NRG Comments on the NYISO Final Recommendations for the Demand Curve Reset (DCR)

NRG provides these comments to the NYISO Staff Recommendations for the 2016 DCR. NRG has submitted comments on the Draft Analysis Group (AG) Report and the NYISO Staff Draft Recommendations. In these final comments, we summarize the key points we have made in previous submissions. NRG also requests time for an Oral Argument before the NYISO BOD on October 17, 2015.

Source: NYISO Consumer Impact Analysis, September 25, 2015.

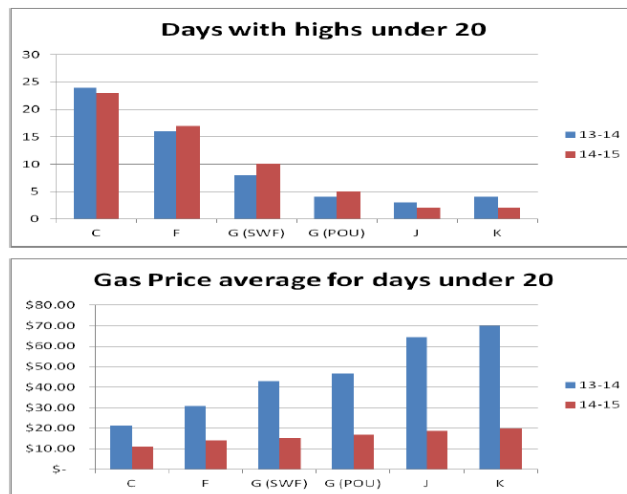
- 3) NYISO’s Consumer Impact Analysis makes it clear that a Developer siting a new unit would choose to site with dual fuel. Gas prices over the last couple of Winters support the argument that a Developer would seek to manage gas price uncertainty, with the option to run on multiple fuel types. Upstate NY experienced colder-than-average temperatures over the past several years,³ with very different gas price impacts. Managing this pricing uncertainty with dual fuel is likely to remain a valuable option.
